Village of Arlington Heights
Plan Commission
Board Room
Arlington Heights Village Hall
33 S. Arlington Heights Road
Arlington Heights, IL 60005
December 14, 2016
7:30 PM

- A. Medical Office -1519 S. Arlington Heights Rd. - PC#16-022
Rezoning, Subdivision, PUD, Amendment to PUD
- B. Arlington Heights Animal Hospital - 412 W. Algonquin Rd. -
PC#16-023
Land Use Variation for a Kennel

RE: LEXINGTON HERITAGE TOWNHOMES - PC# 16-021

SANITARY SEWER EXTENSION STA:0+00 to STA:5+00

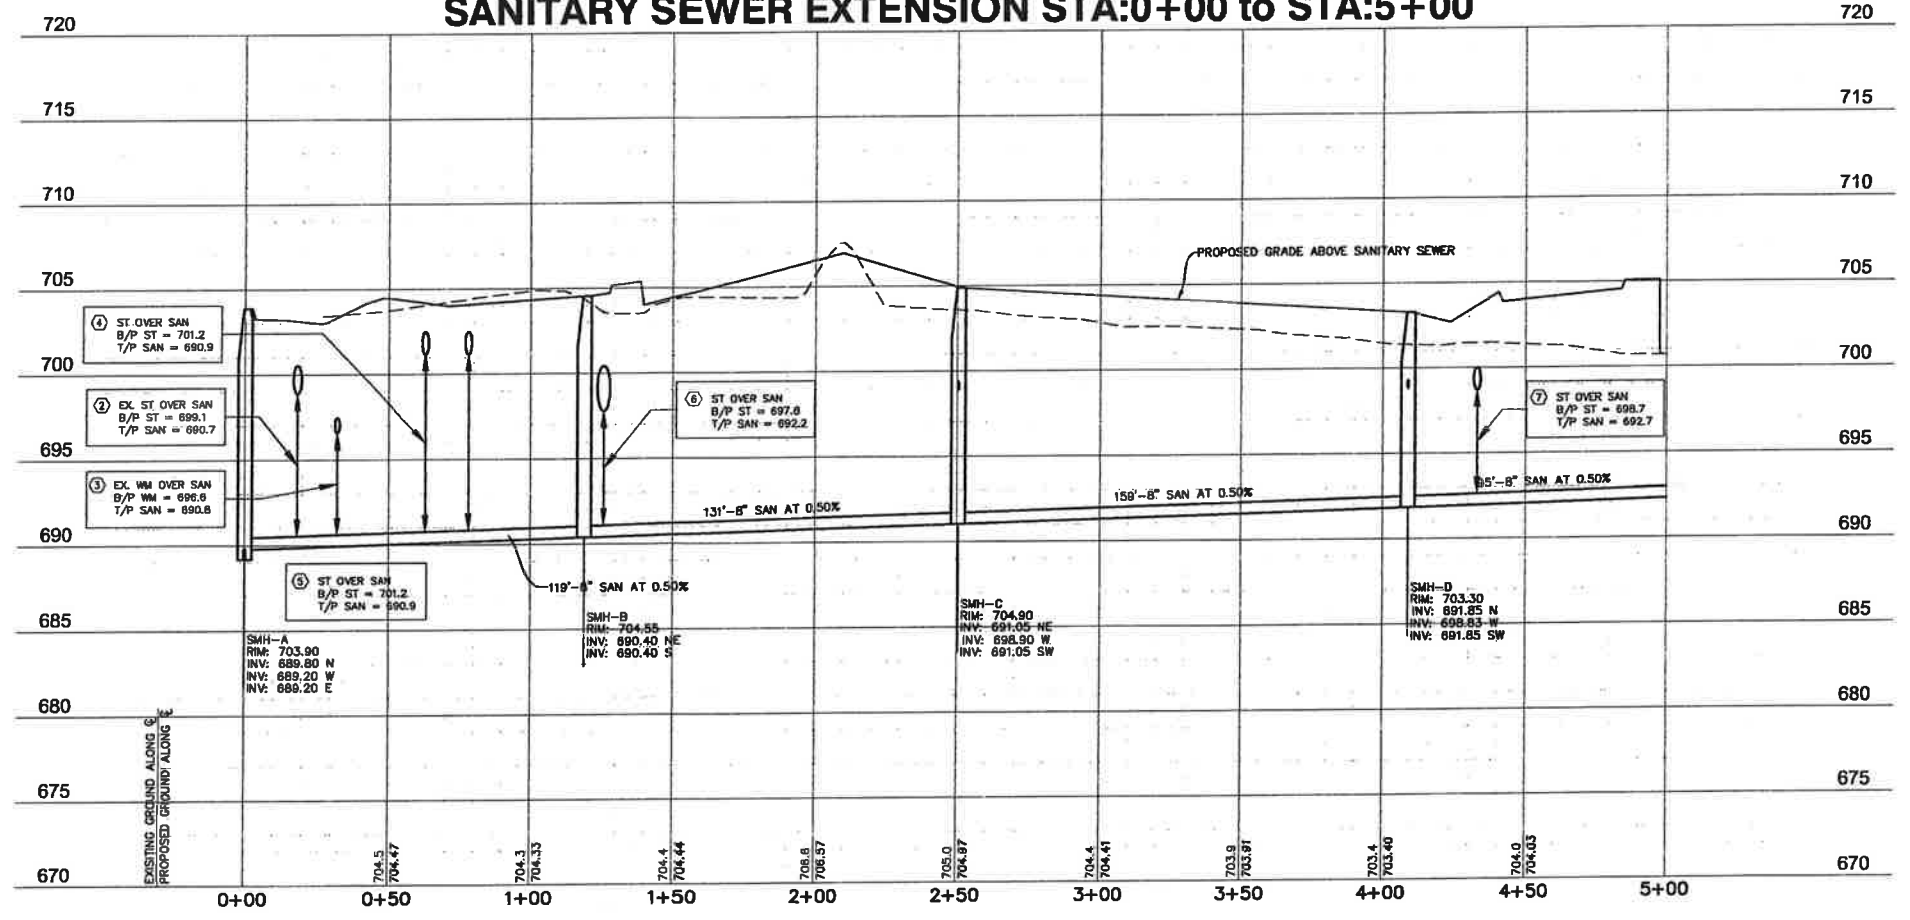
32. Sheet #7: Subdivision requirements include the extensions of public utilities to service the subdivided lots and any adjacent future developments. The lots to the north of the subject property cannot easily be serviced by existing public sanitary sewers. As a required public improvement, the public sanitary sewer must be connected to the existing main that crosses the Autumn Leaves site and extended north to the northern property boundary. This can be accomplished within the Arlington Heights Road ROW, in an easement adjacent to Arlington Heights Road ROW, or within an easement behind the building similar to the proposed easement as shown on the plat. If located within an easement, an additional public easement will be necessary for where the main crosses onto the Autumn Leaves property. The sanitary main shall be 8" diameter and will require an IEPA sanitary permit.

Sheet #7: Subdivision requirements include the extensions of public utilities to service the subdivided lots and any adjacent future developments. The lots to the north of the subject property cannot easily be serviced by existing public sanitary sewers. As a required public improvement, the public sanitary sewer must be connected to the existing main that crosses the Autumn Leaves site and extended north to the northern property boundary. This can be accomplished within the Arlington Heights Road ROW, in an easement adjacent to Arlington Heights Road ROW, or within an easement behind the building similar to the proposed easement as shown on the plat. If located within an easement, an additional public easement will be necessary for where the main crosses onto the Autumn Leaves property. The sanitary main shall be 8" diameter and will require an IEPA sanitary permit.

Arlington Heights Fire Truck

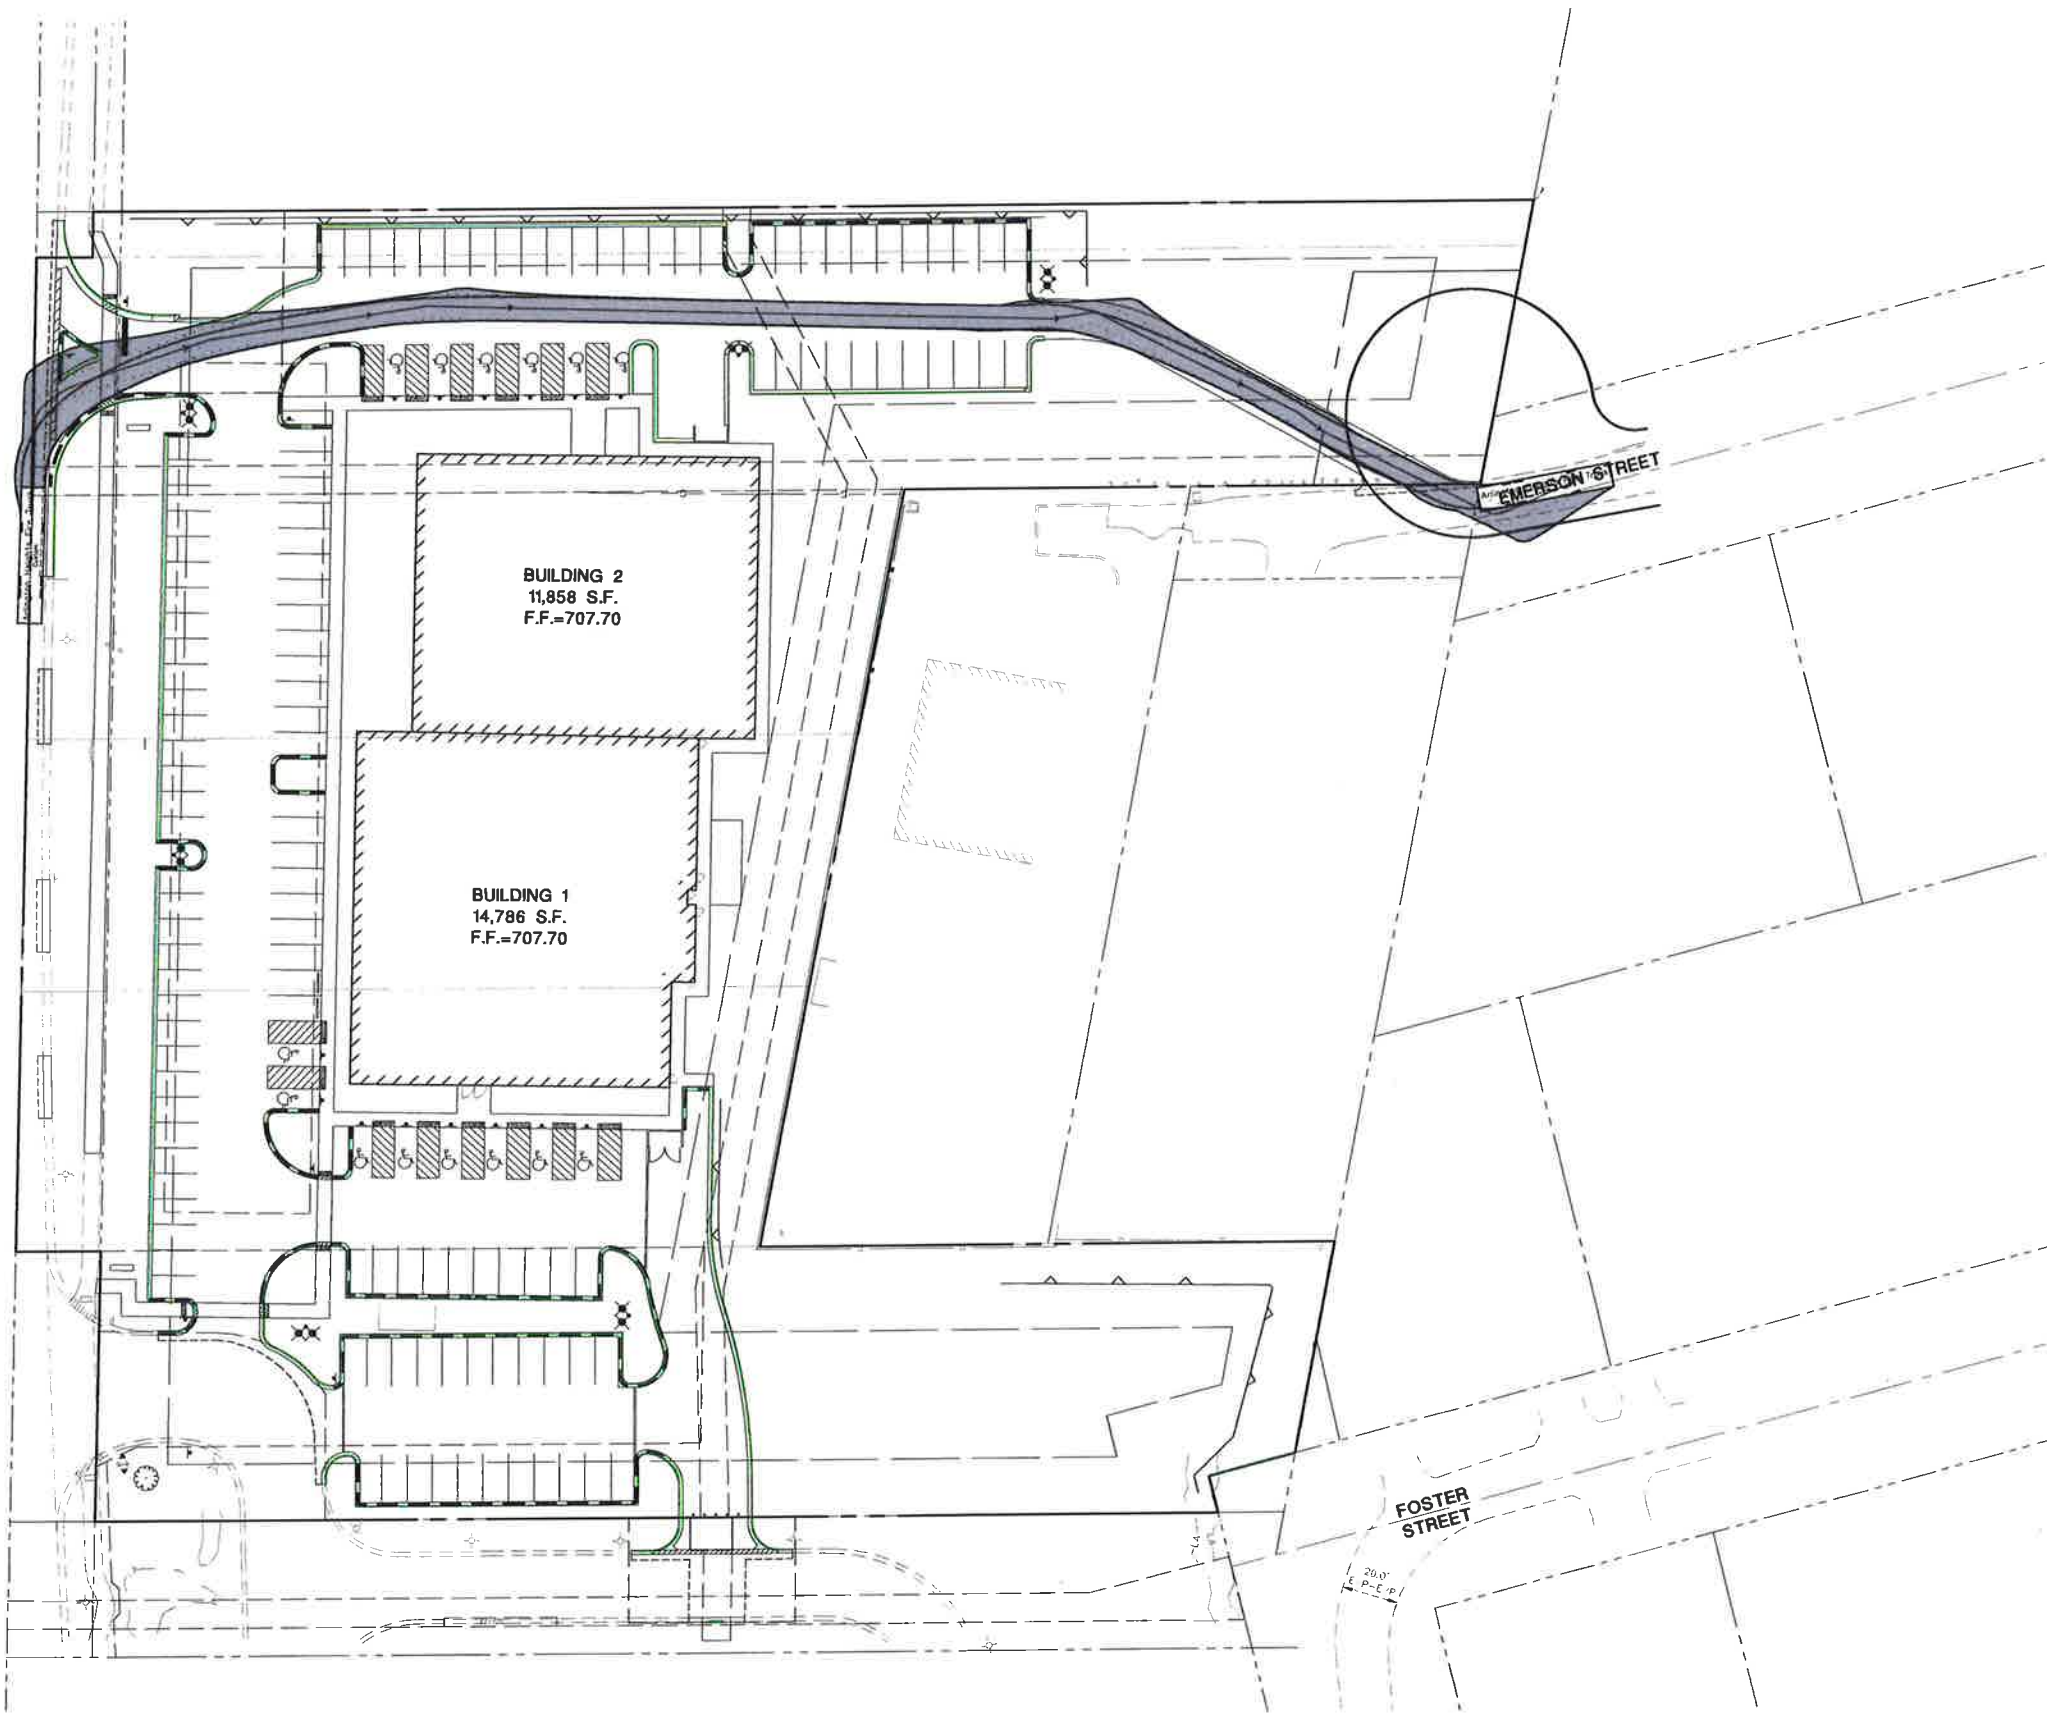
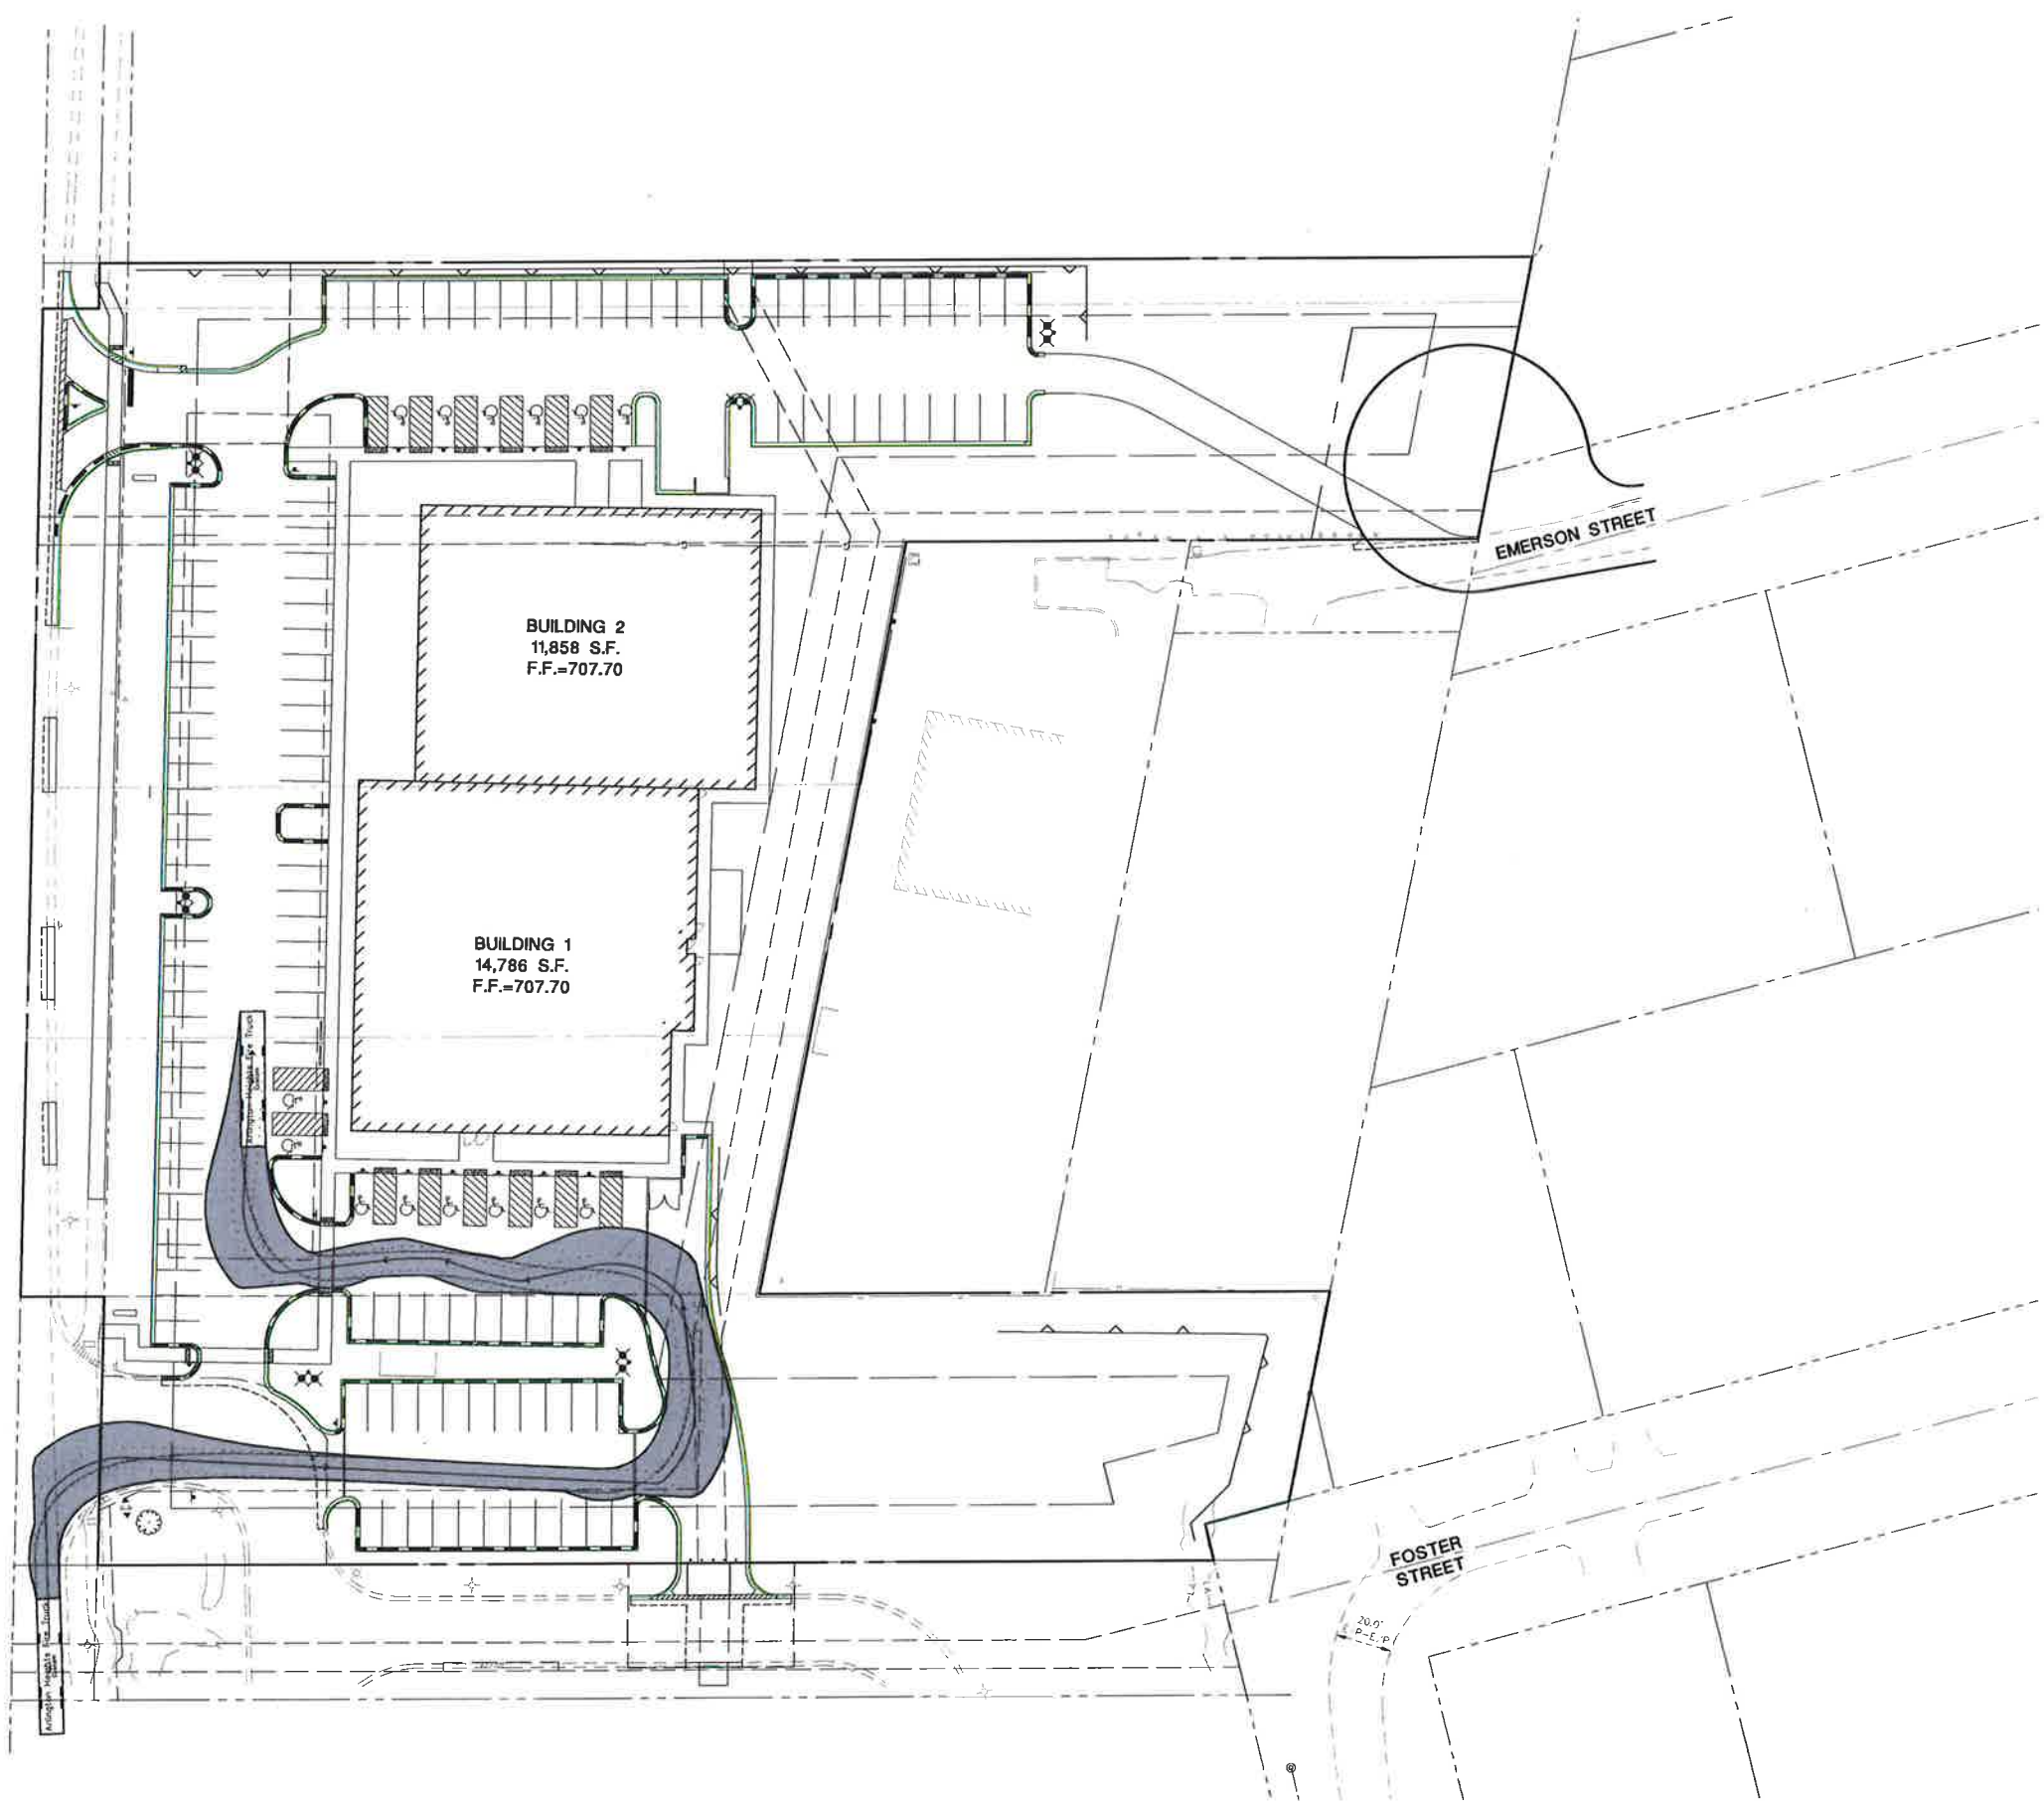
20. We received exhibit sheets 2-4, but not sheet 1 showing the turning path of the Fire Department's responding vehicle. Sheets 2 and 3 have the truck driving over the pork chop median at the north driveway.

We received exhibit sheets 2-4, but not sheet 1 showing the turning path of the Fire Department's responding vehicle. Sheets 2 and 3 have the truck driving over the pork chop median at the north driveway.

Sheet 1 of the Fire Truck Turn Exhibits has been included for review. The pork chop on the right-in/right-out is called out to be mountable curb.
